## 14-18 Boondah Road, Warriewood

August 2010

Prepared for **Meriton Apartments Pty Ltd**

Major Project MP 09\_0162  
Preferred Project Report

**Figure 3. Preferred Concept Plan street network plan**

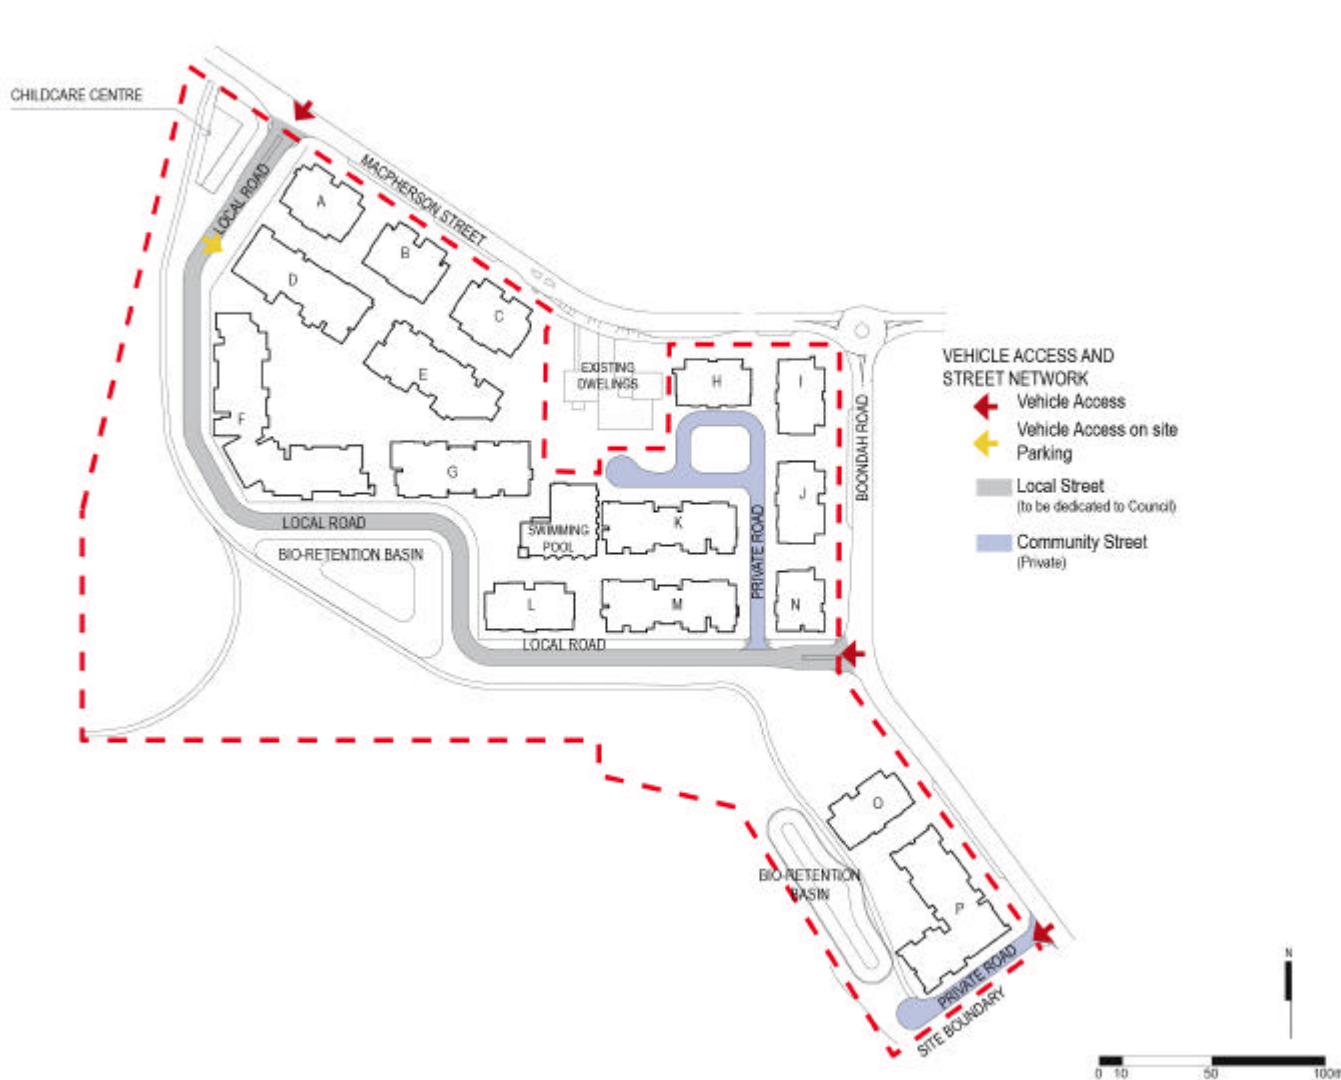
The private road to Building O and P has been moved to the south eastern side of Building P.

**Figure 3** illustrates the revised vehicle access and street network in the Preferred Concept Plan.

Figure 7. 9.00am June 21 (midwinter) shadow diagram

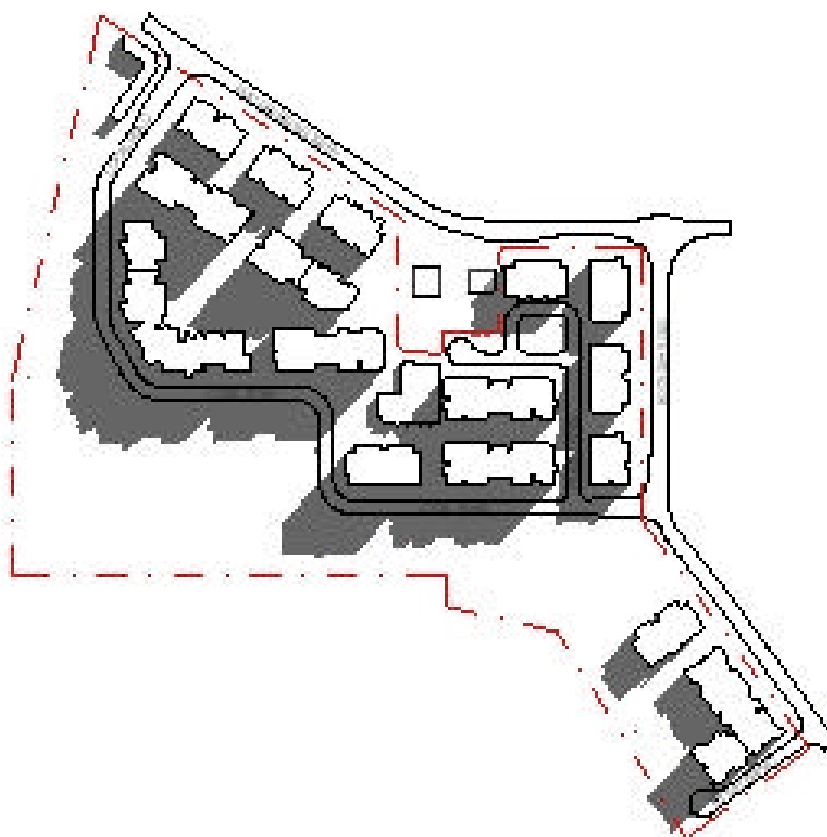
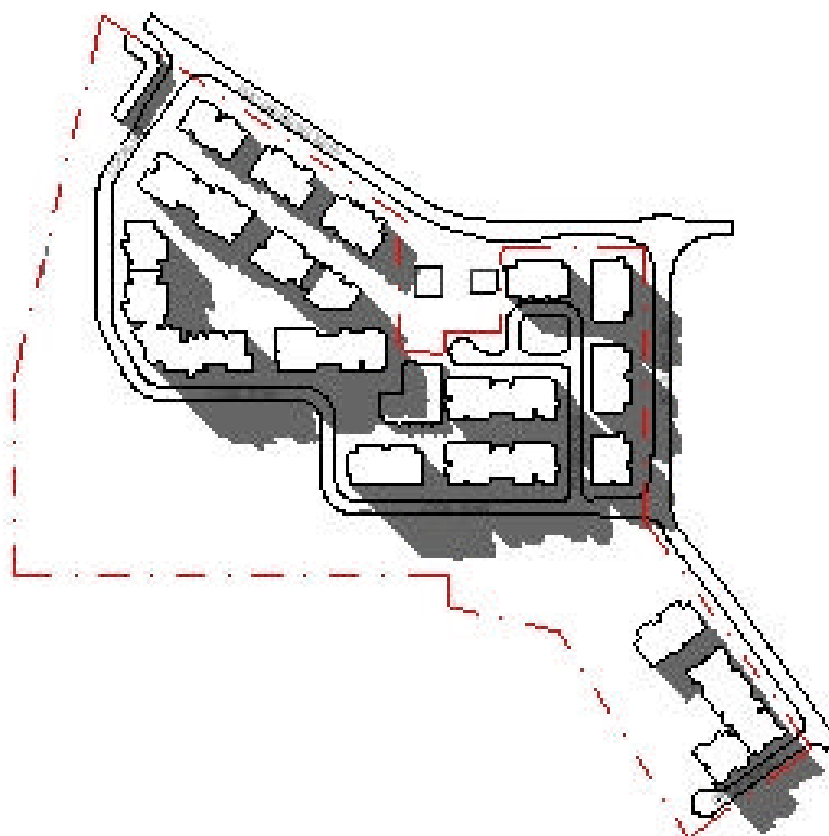
The shadow diagrams submitted with the exhibited Environmental Assessment for the Concept Plan have been revised showing the overshadowing impact of buildings in the Preferred Concept Plan.

**Appendix C** provides shadow diagrams for the Preferred Concept Plan at 21 March, 21 June, 21 September and 21 December.

Figure 10. Staging plan

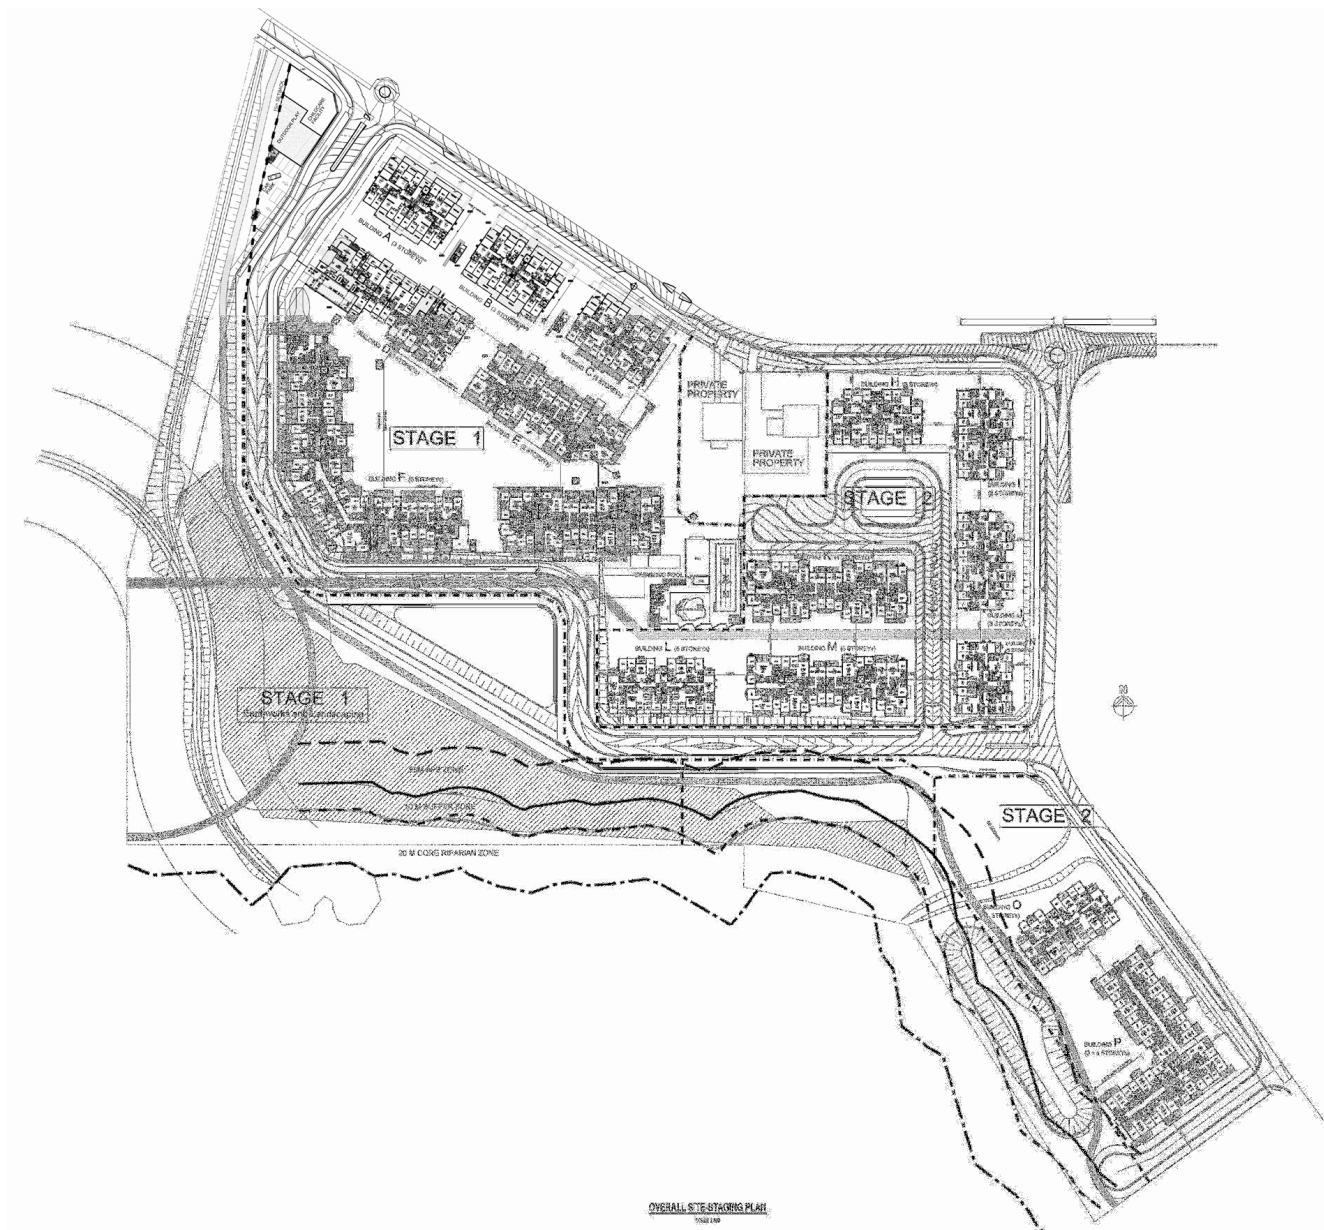
**Figure 10** illustrates the staging of development.
